LR-N20-0043
LAR H19-07

Hope Creek Generating Station
Renewed Facility Operating License No. NPF-57
NRC Docket No. 50-354

Subject: Response to Request for Additional Information, Re: Adopt 10 CFR 50.69 LAR

Response to Request for Additional Information - Application to Adopt Title 10 of the Code of Federal Regulations 50.69, "Risk-Informed Categorization and Treatment of Structures, Systems and Components for Nuclear Power Reactors"

Figure 5c-1: PRAQUANT and FRANX Convergence by Decade

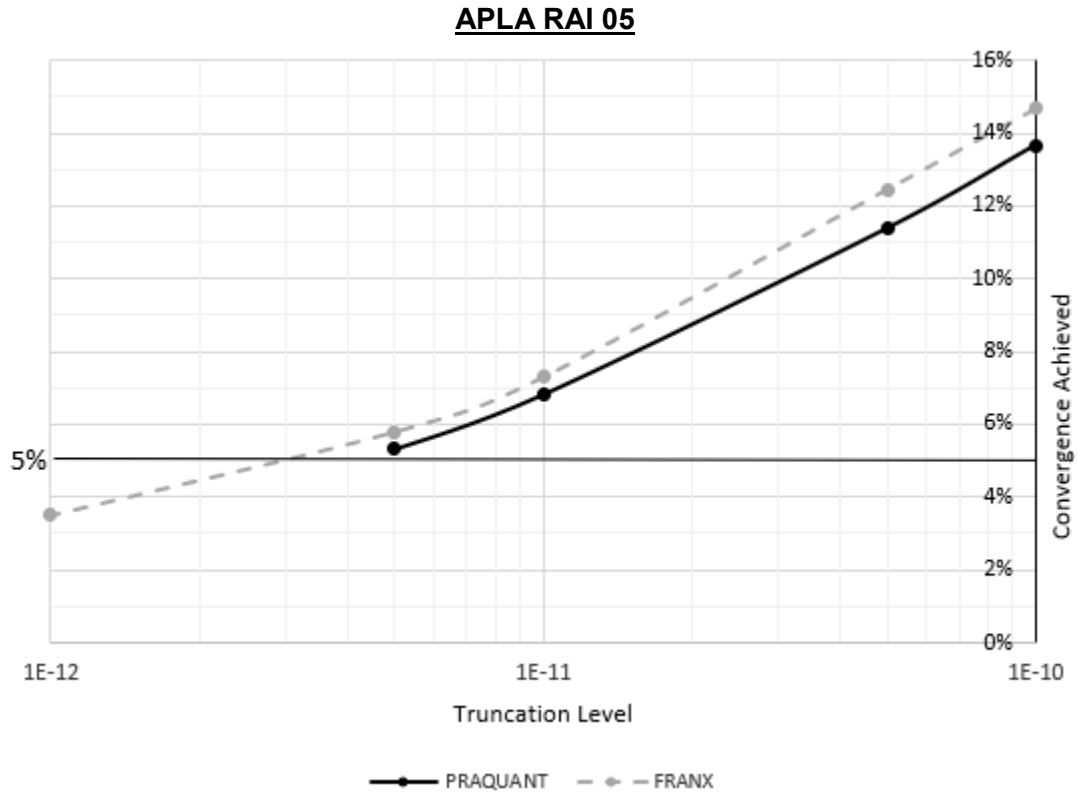
- i. Provide the actual LERF convergence value achieved.
- ii. Provide justification, such as a sensitivity study, that using a truncation value that does not achieve convergence does not impact the results of the 10 CFR 50.69 categorization process.

Table 5c-1 shows the PRAQUANT and FRANX Fire LERF calculations over four decades, to demonstrate that the model reaches less than 5% convergence between the 1E-12 and 1E-13 decades. The 1E-13 truncation quantification results for PRAQUANT are unknown due to software limitations, so convergence numbers are shown for the 1E-10 to 1E-11, 5E-11 to 5E-12, 1E-11 to 1E-12 and 5E-12 to 5E-13 decades for both methods, and the 1E-12 to 1E-13 decade for FRANX. Figure 5c-1 graphically maps the truncation decade to the convergence achieved for both PRAQUANT and FRANX for additional clarity. Note that the lines present on Figure 5c-1 are not formulaic, but instead simply connect the points of the graph for improved visualization.

Figure 1: GMRS and SSE Response Spectra for HCGS
From Reference [4]

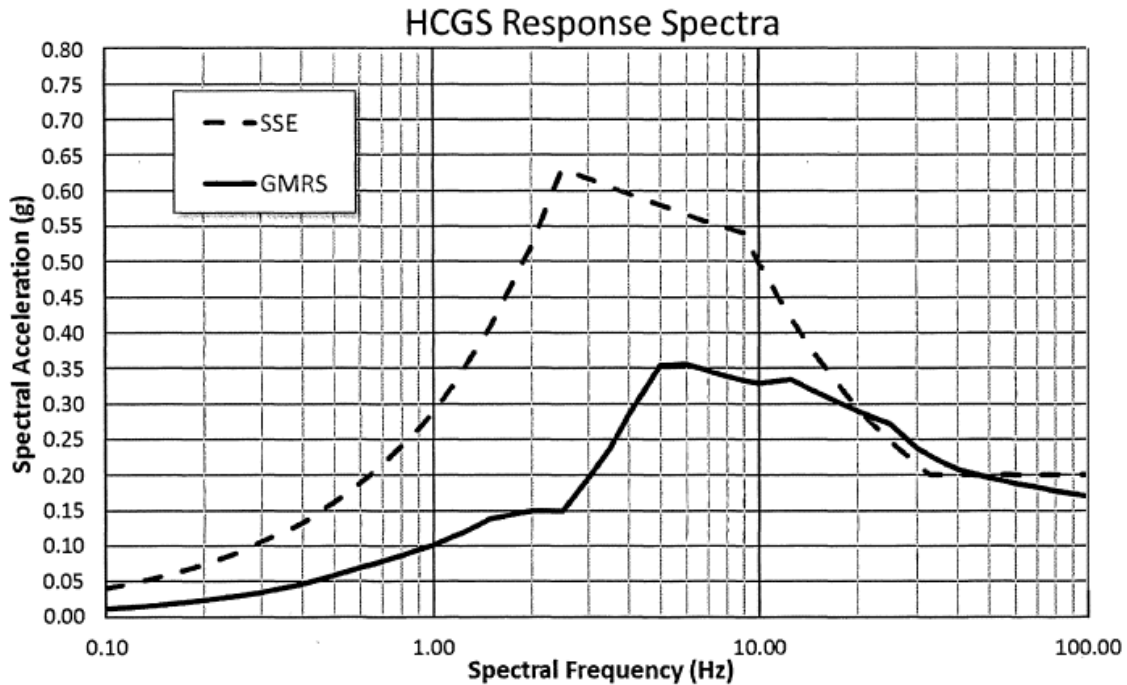
Justify that the plant-specific seismic risk is low relative to the overall plant risk such that the categorization results will not be significantly impacted to support the applicability of the proposed alternate seismic approach.

For the HCGS site, the GMRS-to-SSE comparison taken from the LAR and shown below in Figure 1 demonstrates that the GMRS is well below the SSE between 1 Hz and 10 Hz which qualifies it as a Tier 1 plant under the criteria in the EPRI report. These criteria are similar to the grading process used in EPRI 1025287 (Reference [2]) for the Fukushima 50.54(f) letter responses and in NEI 12-06 (Reference [3]) for the Mitigation Strategy Assessment. This comparison also confirms that the expected seismic risk at HCGS would be very low. Structures, systems, and components (SSCs) designed to the SSE level would have significant seismic capacity margins beyond the GMRS seismic level, which would result in high median capacities, and therefore would produce low seismic risk values.
